Proposed Change RTS 117 To
The Duane Arnold Energy Center
Technical Specifications

The holders of License DPR-49 for the Duane Arnold Energy Center propose to amend Appendix A (Technical Specifications) to said license by deleting current pages and replacing them with the attached new proposed pages. A list of the affected pages is attached with the proposed new pages.

Proposed Change RTS 117 to DAEC Technical Specification

FIGURE 3.12-7

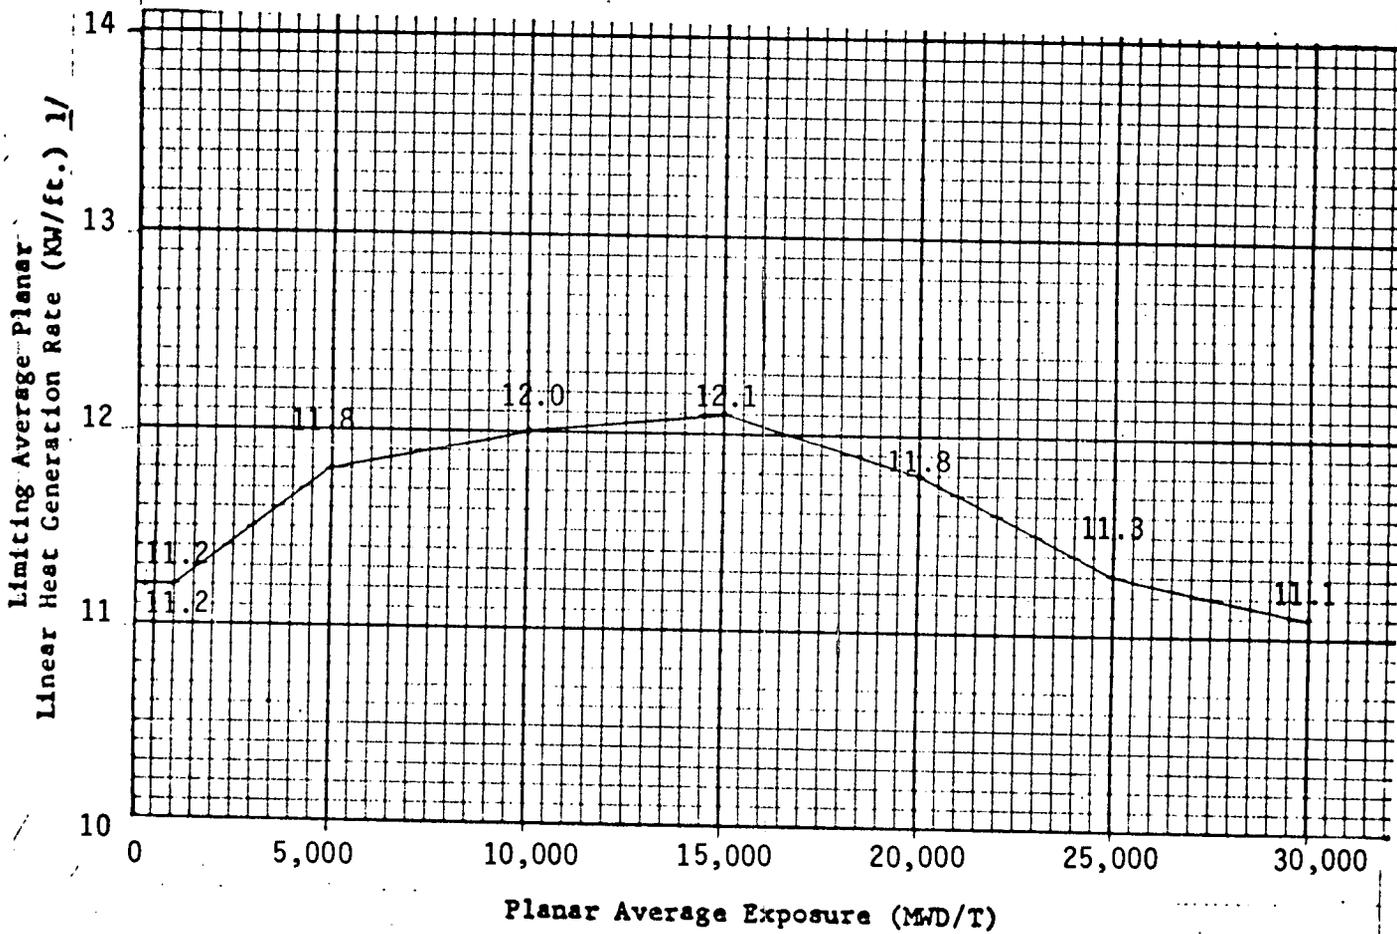
During reactor power operation, the actual MAPLHGR for each type of fuel as a function of average planar exposure shall not exceed the limiting value shown in Figs. 3.12-2, -3, -4, -5, -6, and 7. If at any time during reactor power operation it is determined by normal surveillance that the limiting value for MAPLHGR (LAPLHGR) is being exceeded, action shall then be initiated within 15 minutes to restore operation to within the prescribed limits. If the MAPLHGR (LAPLHGR) is not returned to within the prescribed limits within two hours, the reactor shall be brought to the cold shutdown condition within 36 hours. Surveillance and corresponding action shall continue until the prescribed limits are again being met.

1/ When core flow is equal to or less than 70% of rated, the MAPLHGR shall not exceed 95% of the limiting values shown.
